<b>AMENDMENT OF SOLICITATION/MODIFICATION OF CONTRACT</b>				1. CONTRACT ID CODE <b>J</b>		PAGE OF PAGES <b>1   2</b>	
2. AMENDMENT/MODIFICATION NO. <b>0001</b>		3. EFFECTIVE DATE <b>20-Oct-2005</b>		4. REQUISITION/PURCHASE REQ. NO. <b>05CDF060</b>		5. PROJECT NO. (If applicable)

14. DESCRIPTION OF AMENDMENT/MODIFICATION (Organized by UCF section headings, including solicitation/contract subject matter where feasible.)  This amendment is replacing Figure 1 found on page 12 and adding/replacing information found on pages 12, 13 and 14 as follows:							
Except as provided herein, all terms and conditions of the document referenced in Item 9A or 10A, as heretofore changed, remains unchanged and in full force and effect.							
15A. NAME AND TITLE OF SIGNER (Type or print)				16A. NAME AND TITLE OF CONTRACTING OFFICER (Type or print)			
				TEL: _____ EMAIL: _____			
15B. CONTRACTOR/OFFEROR		15C. DATE SIGNED		16B. UNITED STATES OF AMERICA		16C. DATE SIGNED	
(Signature of person authorized to sign)				BY _____		20-Oct-2005	
				(Signature of Contracting Officer)

AMENDMENT 0001

- Figure 1 found on page 12 of the RFP is being replaced with the following:

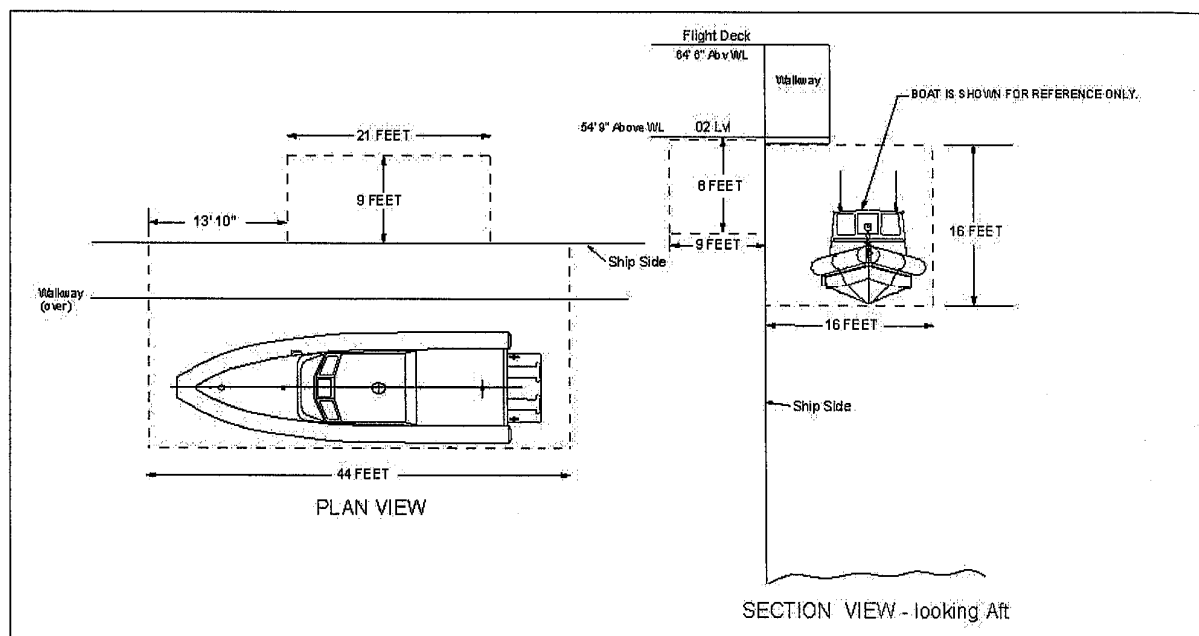
- The following sentence is hereby added to this figure:

"The davit motor controllers are to be remotely located from the davit assembly and are planned to be located within the 21' x 9' space shown in Figure 1.
